ARCHITECTURAL REVIEW COMMITTEE MEMORANDUM

DATE: JANUARY 3, 2022 NEW BUSINESS

SUBJECT: 979 GENE AUTRY LLC, (PROPERTY OWNER) FOR HECATE ENERGY DESERT STORAGE 1 LLC, FOR A MAJOR ARCHITECTURAL APPLICATION FOR REVIEW OF LANDSCAPING AND PERIMETER WALL DESIGN FOR THE DEVELOPMENT OF A 20-MEGAWATT BATTERY STORAGE FACILITY IN A 20,836-SQUARE FOOT LEASED AREA ON THE SOUTHERN END OF A LARGER DEVELOPED 3.6-ACRE SITE LOCATED AT 979 SOUTH GENE AUTRY TRAIL, ZONE M-1. (CASE 3.4294 MAJ)(GM)

CONCEPTUAL LANDSCAPE PLAN

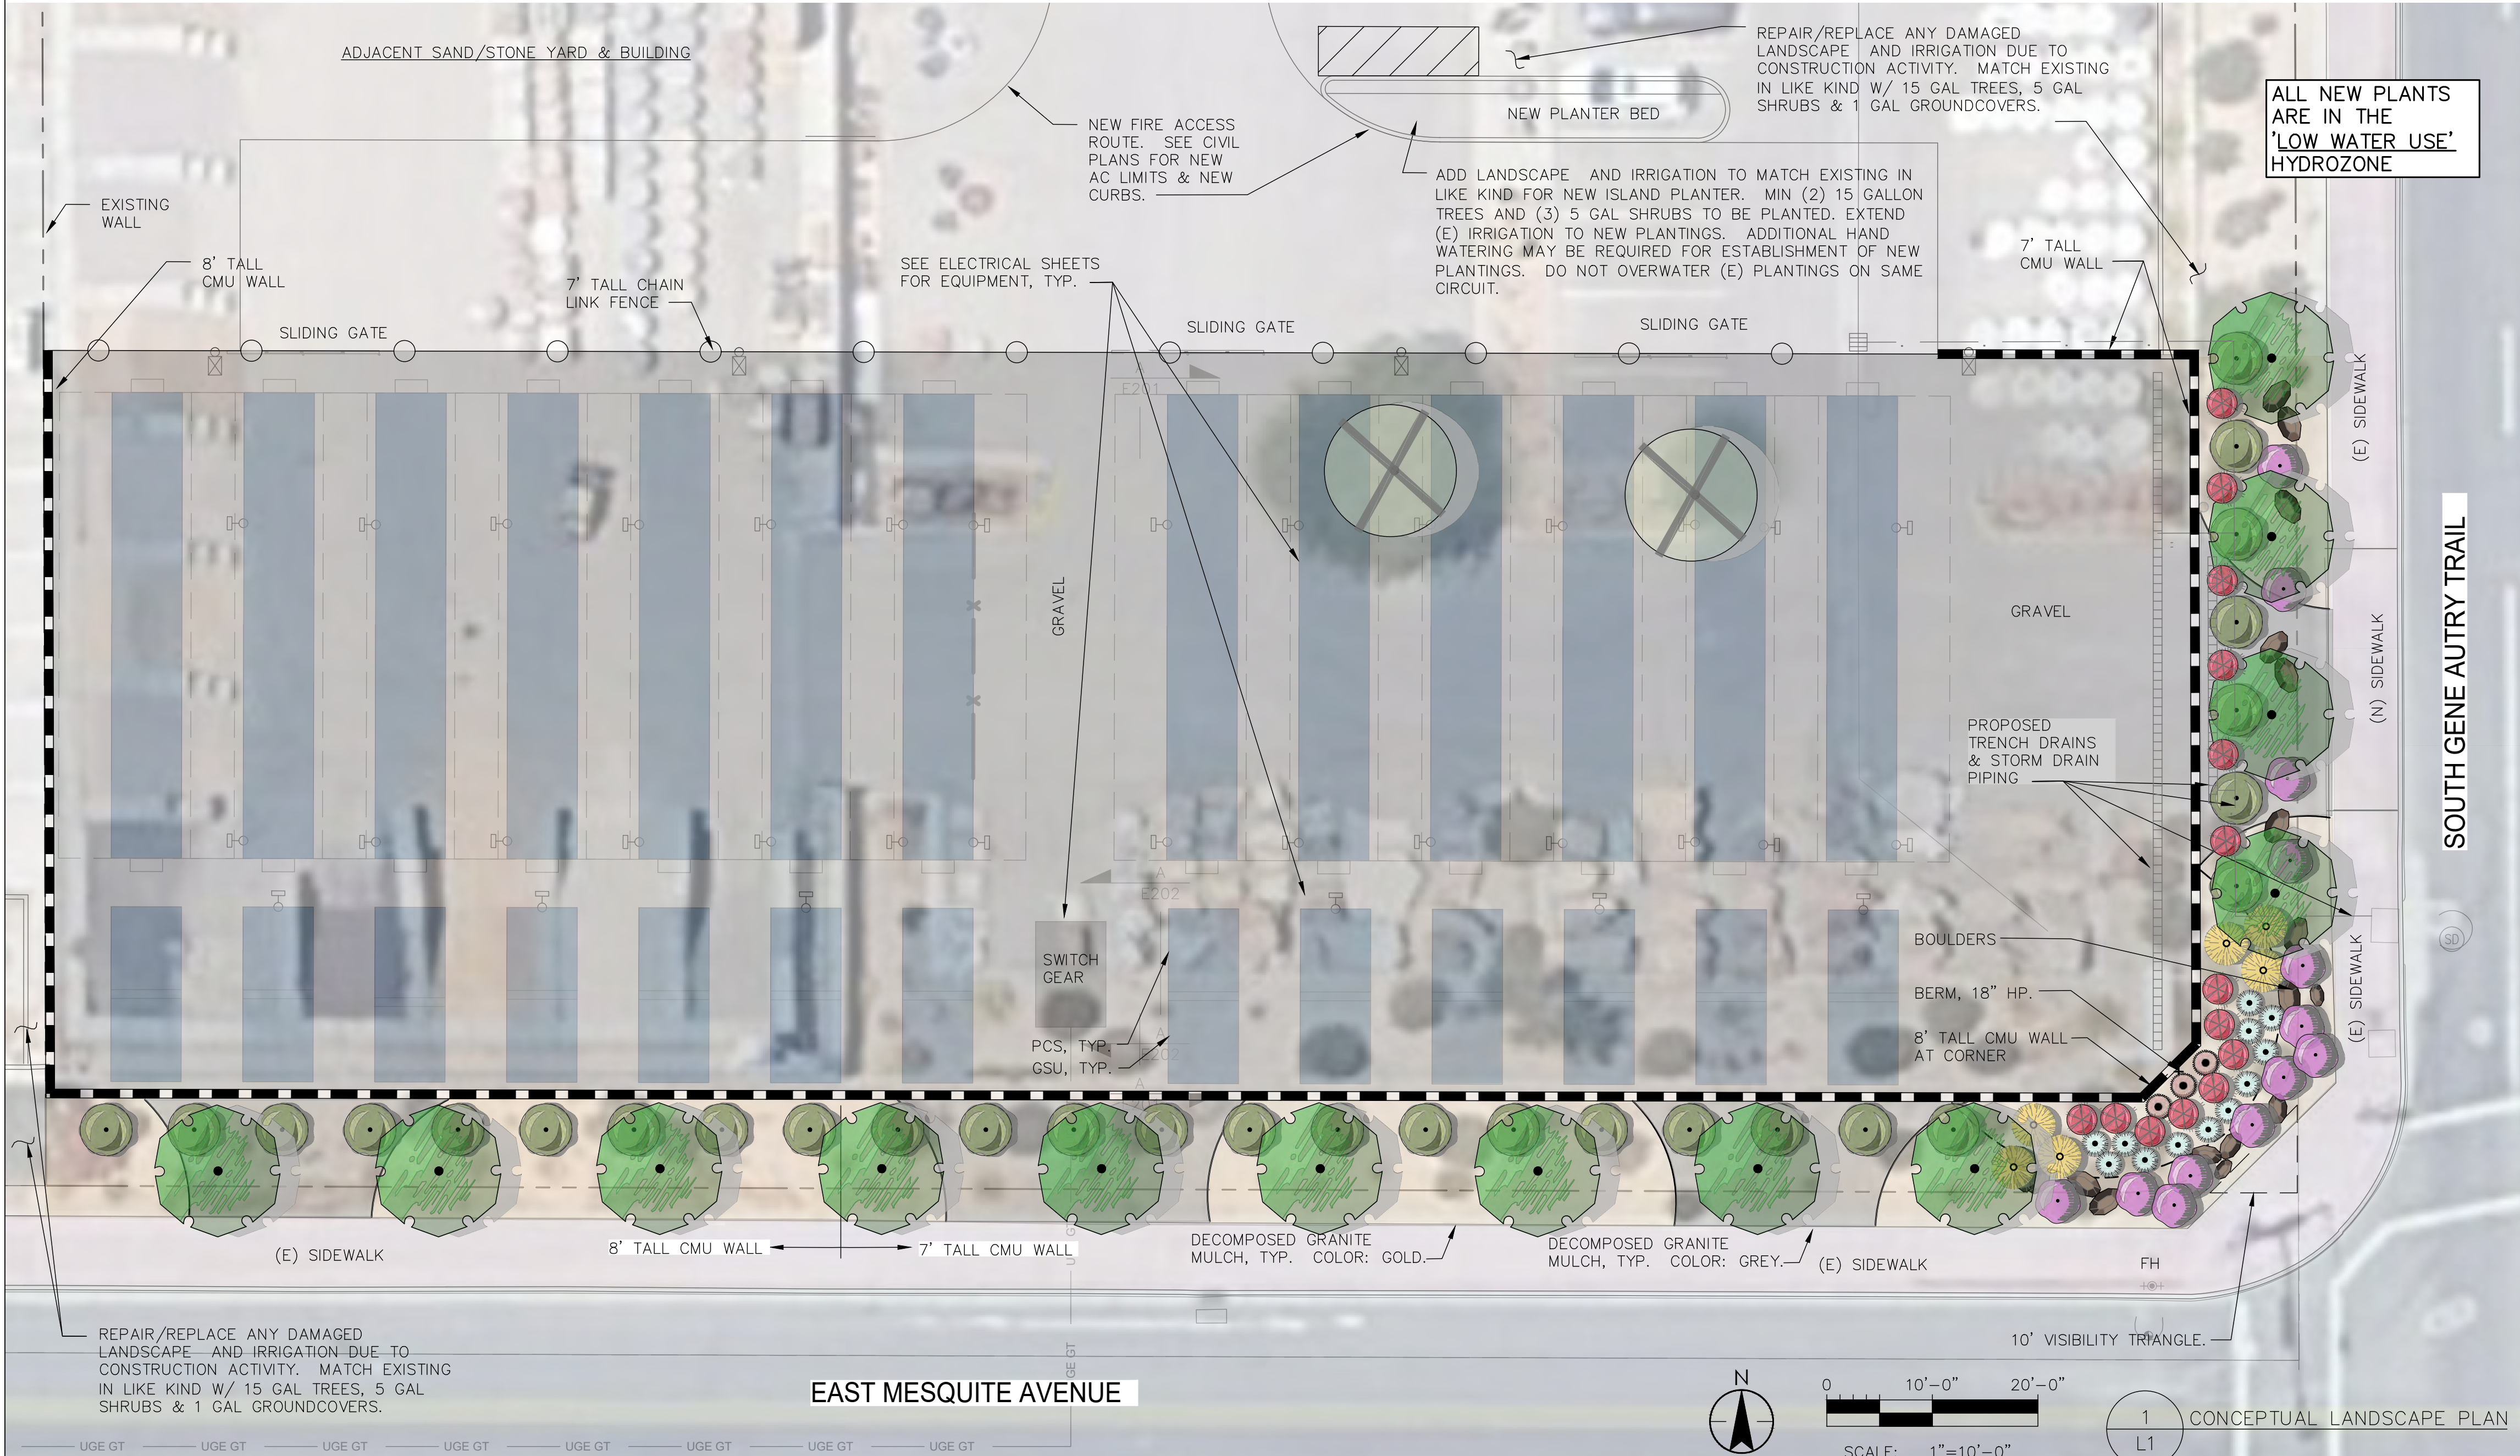
- a. Ground cover to be minimum of 3/8 gravel or larger.
- b. Provide plants that will soften the perimeter wall such as climbing vines or other plant material.
- c. Palo Verde trees to be 36" box in size.
- d. Provide irrigation plan.

- 1. Ground cover to be minimum of 3/8 gravel.
 - 2. Provide plants that will soften the perimeter wall such as climbing vines or other plant material.

- 3. Palo Verde trees to be 36” box in size.
 - 4. Provide irrigation plan.
- D. On January 3, 2022, the City’s Architectural Review Committee held a public meeting in accordance with applicable public law. At said meeting, the Architectural Review Committee carefully reviewed and considered all of the evidence presented in connection with the Project, including, but not limited to, the staff report, and all written and oral testimony presented.

1. Ground cover to be a minimum of 3/8 gravel or larger.
2. Provide plants that will soften the perimeter wall such as climbing vines or other plant material.
3. Palo Verde trees to be 36" box in size.
4. Provide irrigation plan.
